SECTION 6 ERRATA

The following are revisions to the Draft REIR and Recirculated Draft REIR for the September Ranch project. These revisions are minor modifications and clarifications to these documents and do not change the significance of any of the environmental issue conclusions within the Draft REIR or the Revised Draft REIR. The revisions are listed by page number. All additions to the text are underlined and all deletions from the text are stricken.

6.1 Revisions to the Draft Revised Environmental Impact Report (December 2004)

Figure 1

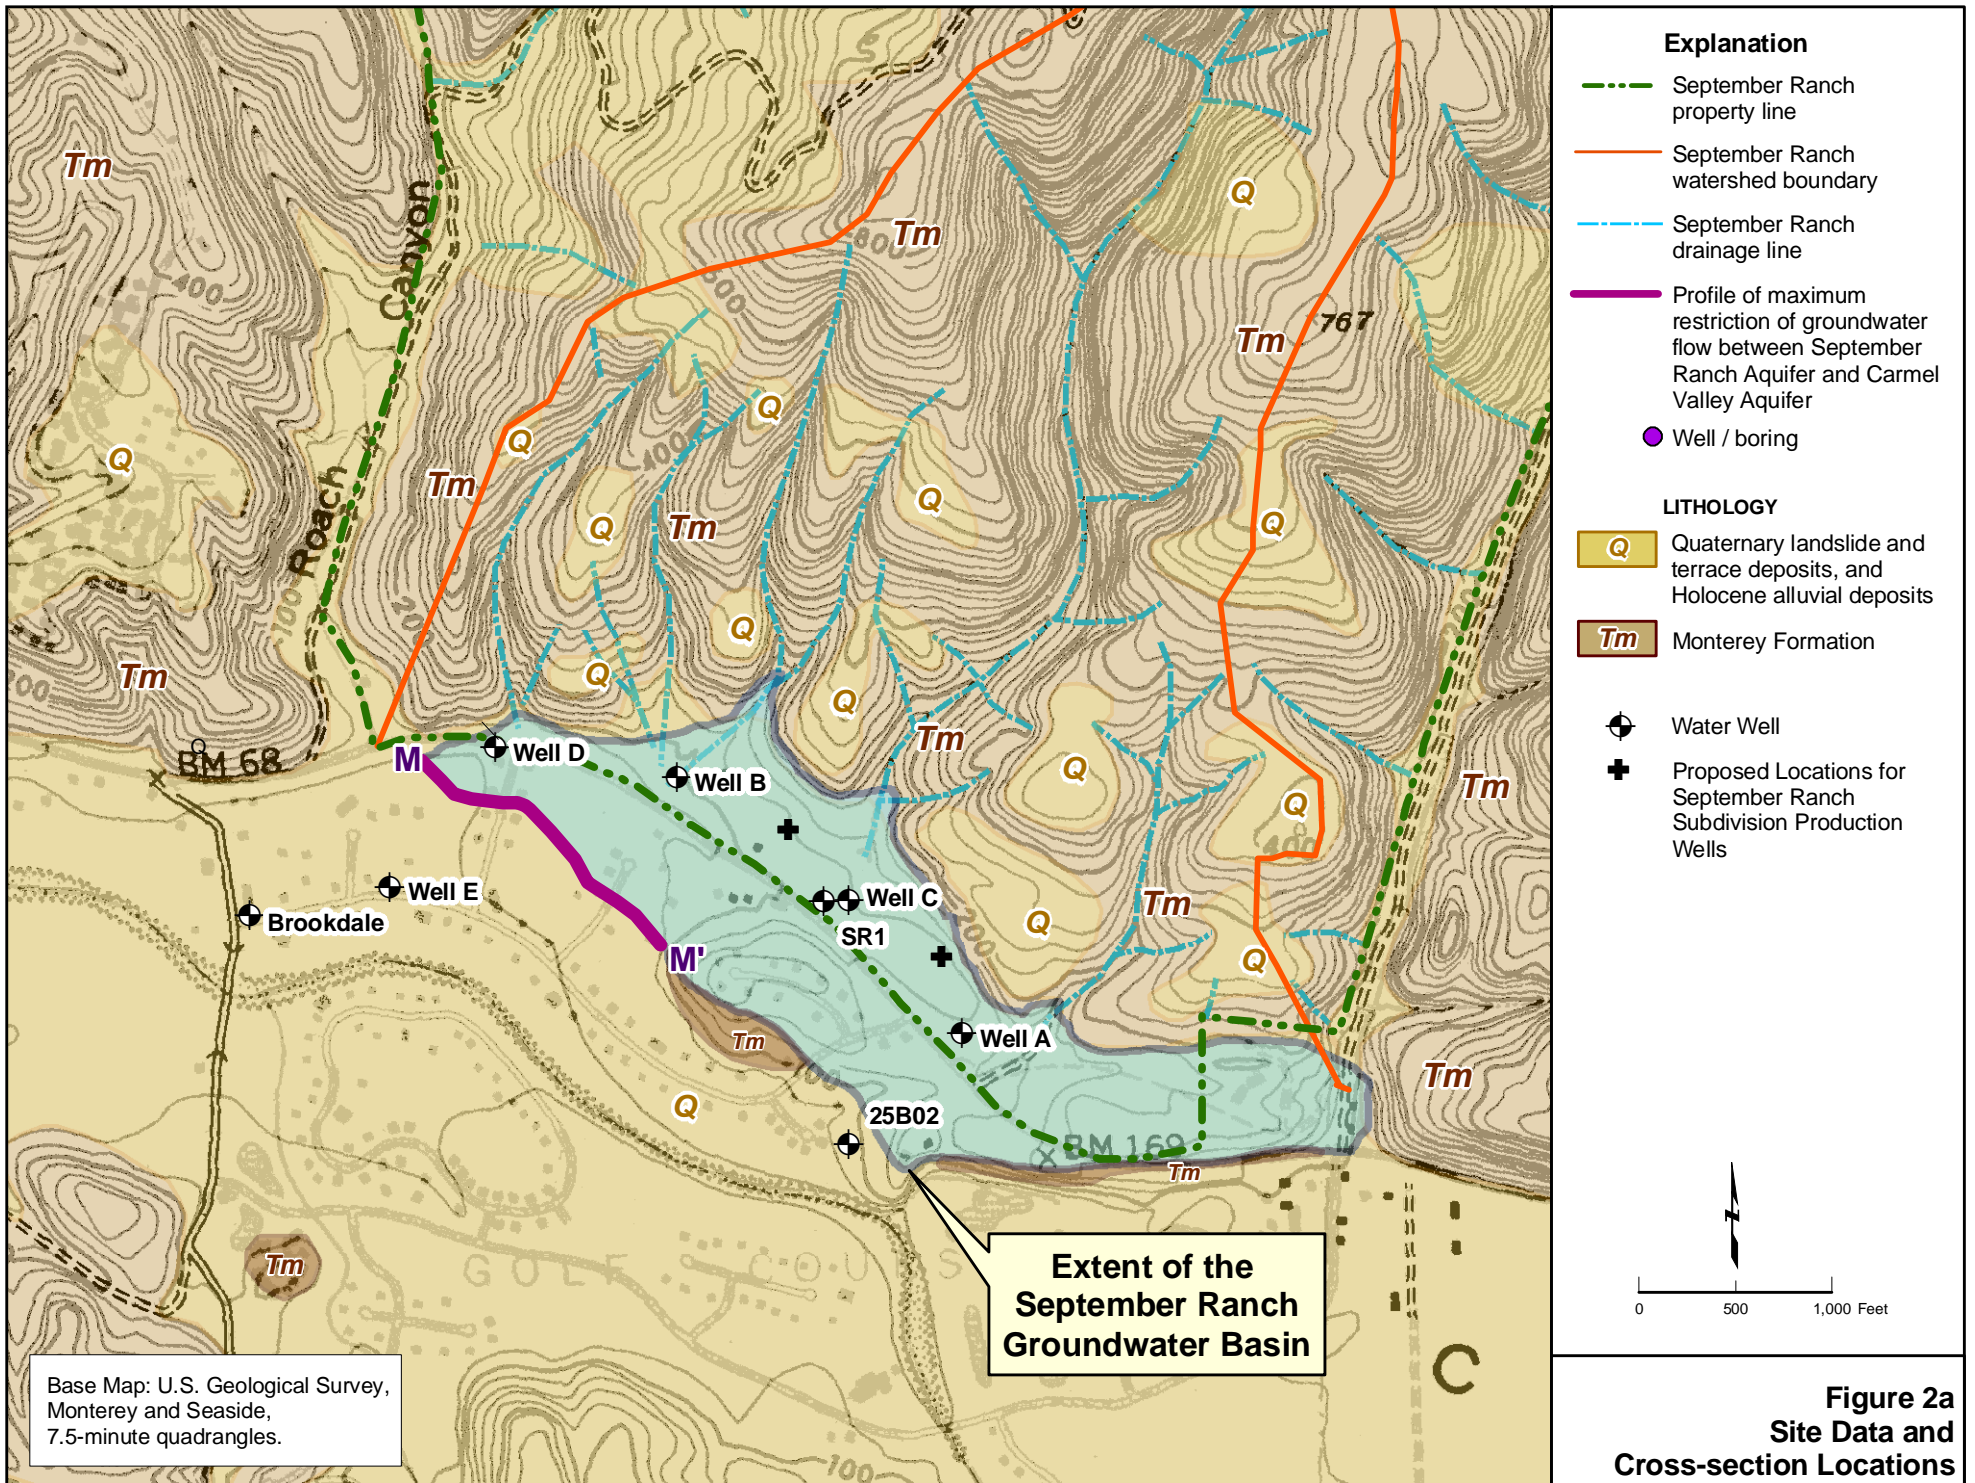
Well SR1 has been added to AQ3 map. Please replace Figures 1 and 2a (presented in Appendix B “Figures” immediately following Appendix A “Tables” with the Hydrogeologic Report [Appendix C] in the 2-13-2006 update) with the versions attached in the following pages of this Section 6, Errata.

Figure 2c
Cross-section M-M'

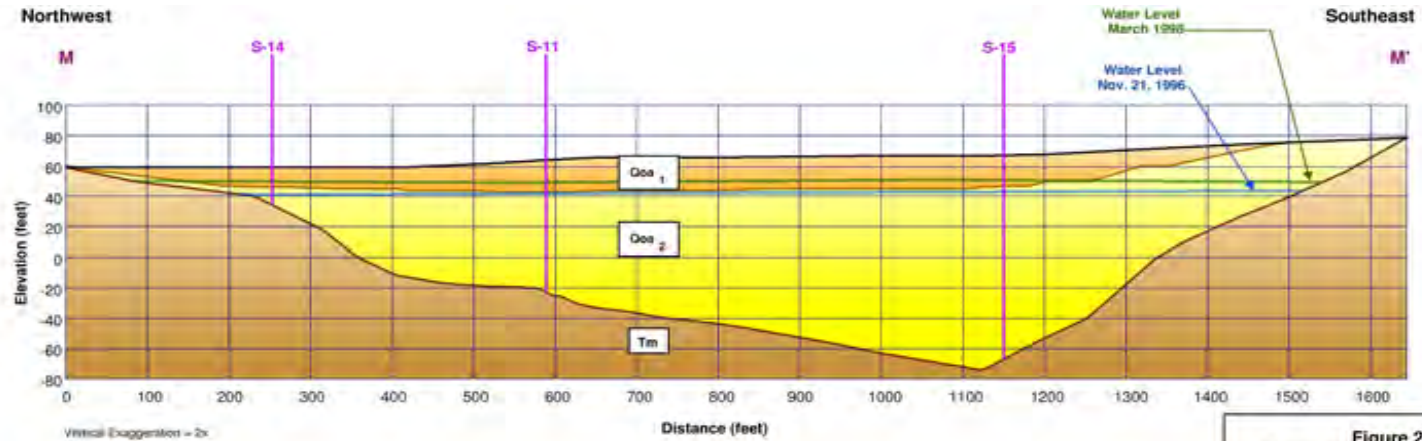
The groundwater exchange occurs largely in an area above the deeper bedrock where the alluvium (Qoa₁ and Qoa₂) is the thickest (Figure 2c in Report, attached). Within that alluvium, the majority of the groundwater exchange, were it to occur, occurs in younger alluvium Qoa₁ because of the significantly higher permeability of Qoa₁ than that of the older alluvium Qoa₂. During average and above average rainfall years, the groundwater exchange occurs in Qoa₁. Drier years can coincide, seasonally, with much larger groundwater gradients between the SRA and the CVA. In drier years, when water levels drop below the Qoa₁, flow can occur only in Qoa₂.
